NOTICE OF REFUSAL OF PLANNING PERMISSION

Proposal: Erection of 4 no. Padel Courts

Location: Stand Cricket And Tennis Club, Hamilton Road, Whitefield, Manchester, M45 7WF

Refusal points made by planners:

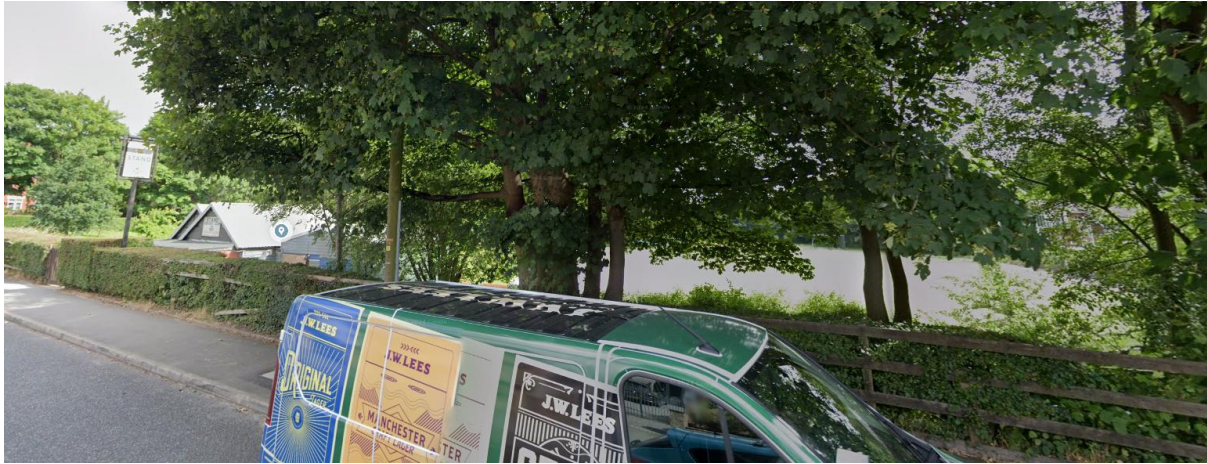
View #1 – Higher Lane

As shown in this Figure 1 above, there is only a 15m stretch on Higher Lane from which there are direct views of the planned courts. Otherwise, due to topographical depression of the site, the clubhouse partly obscures the site and the trees (Parklands side, right) completely obscure the site. This is further demonstrated in the below images.

Figure 2 – view from corner of Parklands and Higher Lane, site completely obscured

Figure 3 – site partially obscured

Figure 4 – 15m stretch from which site is not obscured (corner of Higher Lane and Hamilton Road)

Figure 16 – View from Hamilton Road Park. Extremely dense tree cover over plans (yellow).

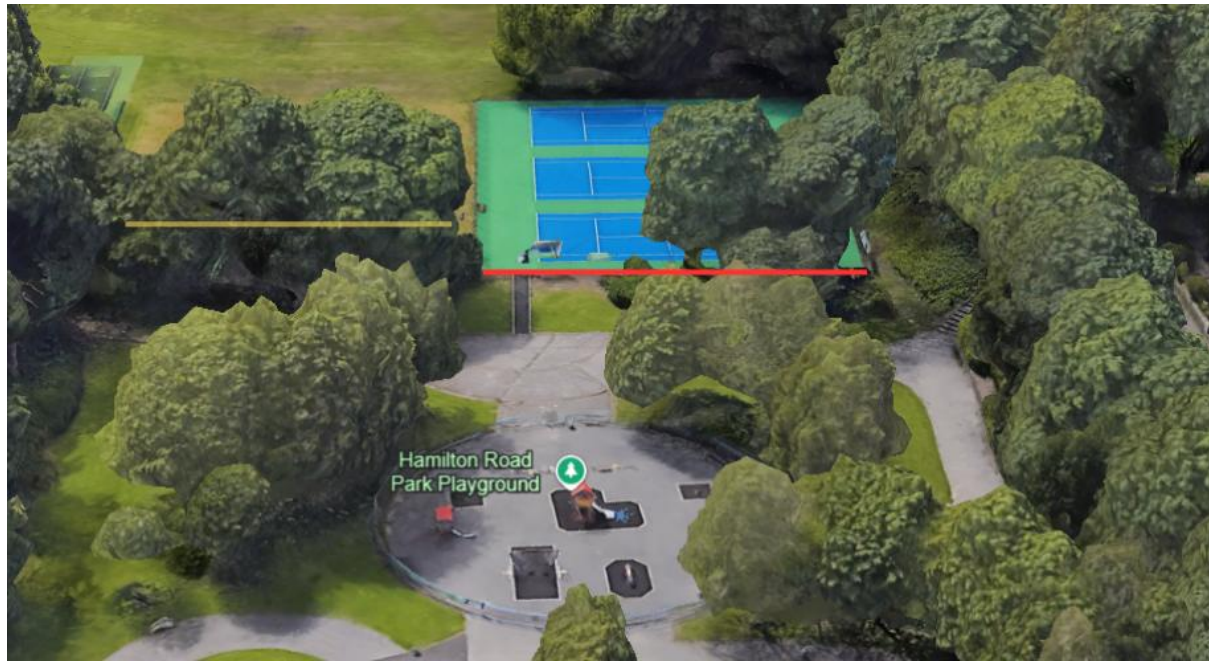
View #5 – Hamilton Road Park

Views of the site from Hamilton Road Park are heavily restricted by extremely dense tree cover. There is no provision within the plans to remove or thin this tree cover. In addition, precedent already exists for the South-West side of Hamilton Road Park to be lined by sporting facilities by way of the existing Tennis Courts, which are in full view of the park and unobstructed by trees. This is demonstrated by Figure 8 above, and Figures 16 and 17 below.

Figure 17 – existing view of Tennis Courts, obstructed view of planned Padel courts (left).
